Township Technical Review Committee (TRC)

MEMORANDUM

Re: Maureen & Edward Matson – “C” Variance (ZBA-21-00024)
51 Arlington Avenue (Block 263.01, Lot 52 & 53)

RISER COVER DETAIL F
N.T.S.

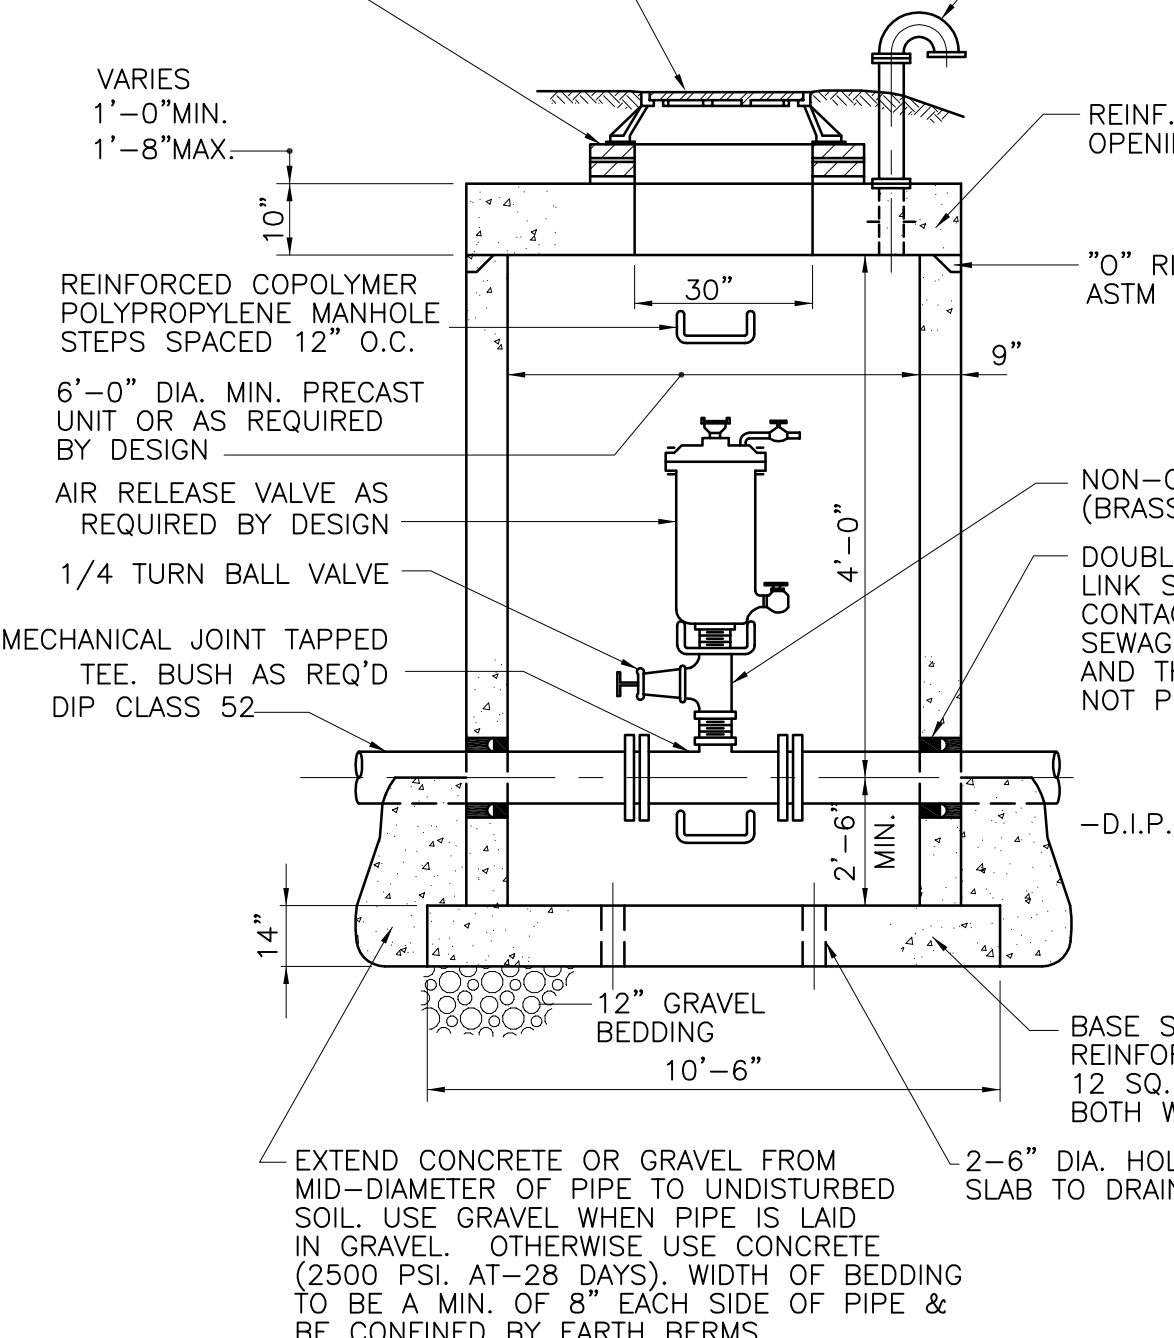
8. Riser Cover shall be NEENAH Model 1976-2301. If desired, the FTSA can provide said Riser Cover to the Applicant at a cost.
9. If trees are proposed, said trees shall not be planted within 10-Feet of the proposed sewer lateral.

SECTION C STANDARD HOUSE CONNECTION DETAIL C
N.T.S.

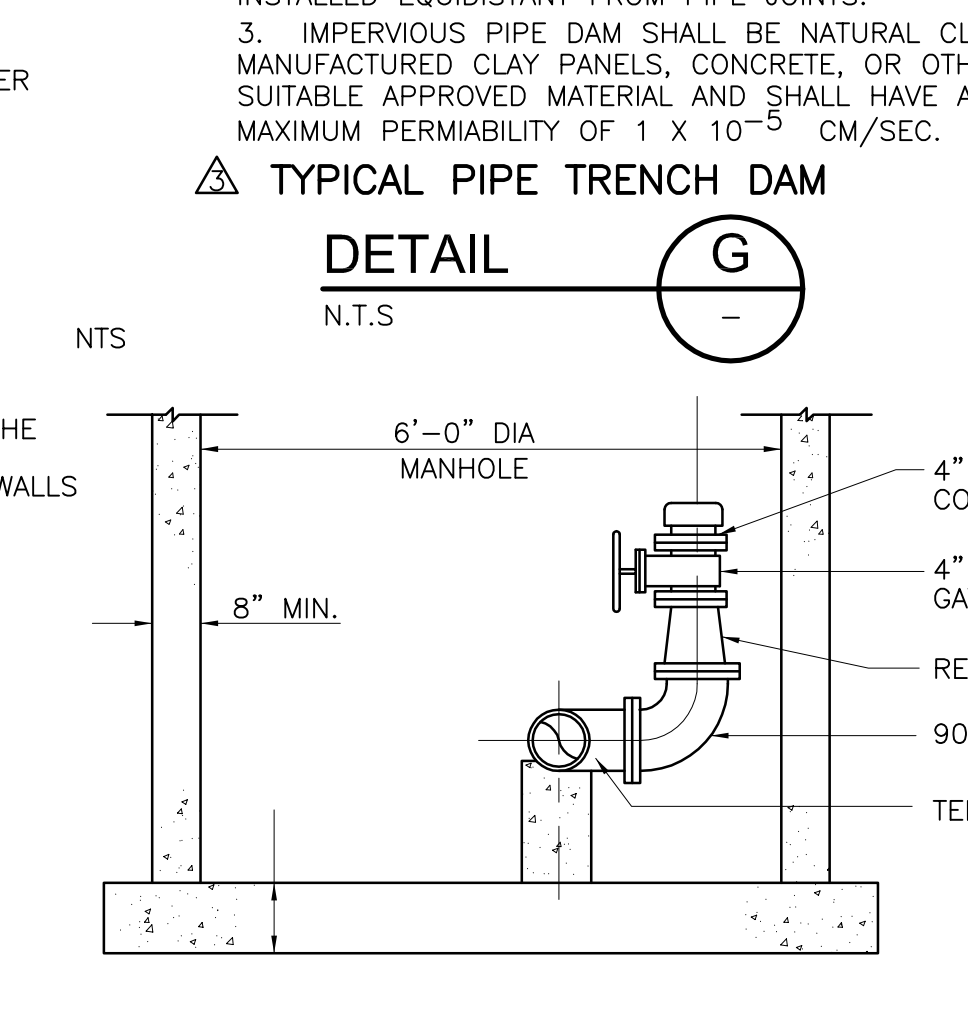
5. Applicant shall comply with the FTSA's Standard Construction Details set forth in its Rules and Regulations, specifically Detail C: "Standard House Connection" and Detail F: "Riser Cover". Same has been attached for the Applicant's use.
